INFORMATION BULLETIN

Bulletin No: JC-015-09

PRODUCTS INVOLVED: STEINER 230 - Serial Numbers; 3001 - 4199

ISSUE: 31-053 F & R Neutral switch is obsolete. Replace it with kit **4164127**

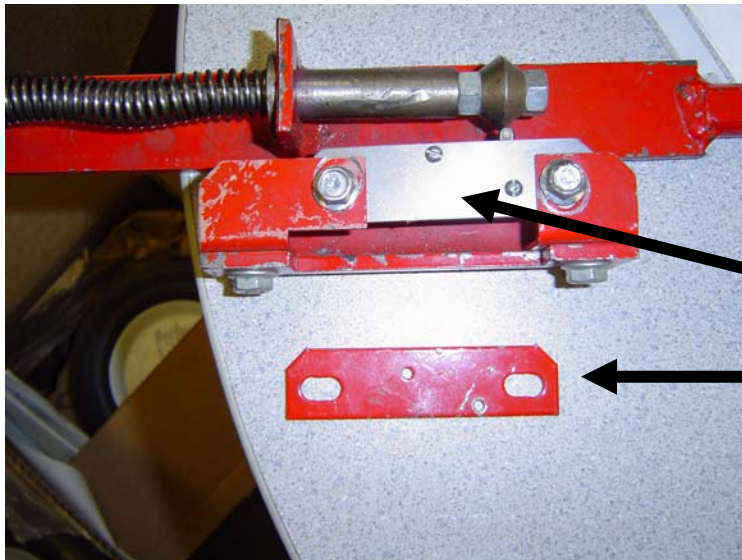
NEW SWITCH AND BRACKET
INSTALLED.

DISCARD OLD SWITCH BRACKET

Switch must be adjusted to work
properly by sliding the bracket in the
slots of the holders.
